TECHNICAL SERVICE BULLETIN

DATE ISSUED	MODEL YEAR(S) AFFECTED	TSB #
04/10/2015	2014-2015	Recall 15V-149 TSB 416

Notice of wiper blade replacement requirement

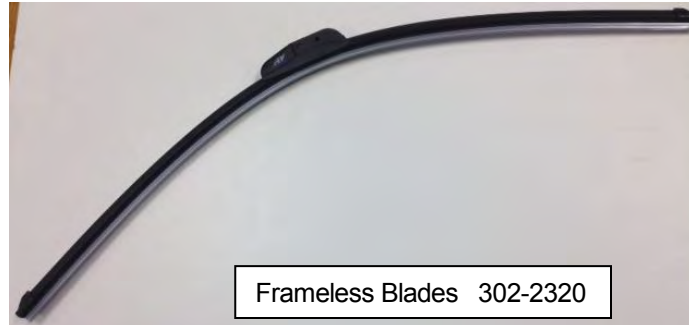
Frameless style windshield wiper blades P/N 302-2320 supplied on designated coaches may separate from wiper arm connector when wiper system is operated at the high speed setting.

Frameless wiper blades P/N 302-2320 MUST be immediately replaced with framed wiper blades P/N 302-1320 supplied with this service bulletin.

To Remove Frameless Blade

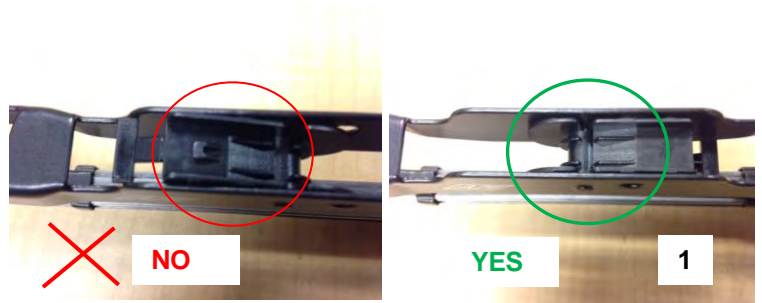
1. Remove frameless blade 302-2320 from wiper arm, driver and passenger side.
DISPOSE OF REMOVED BLADES

1. Lift plastic cover to expose arm hook.
2. Squeeze plastic clip
3. Push blade back to remove from arm

2. Install framed blade 302-1320 on wiper arm, driver and passenger side.

- 1 Orient the plastic retainer to the locking nib faces the down towards the glass
- 2 Slide hook of arm around blade plastic retainer
- 3 "CLICK" blade into place. **Test to insure blades has locked onto the hook securely**
- 4 Remove protective from rubber part of blade
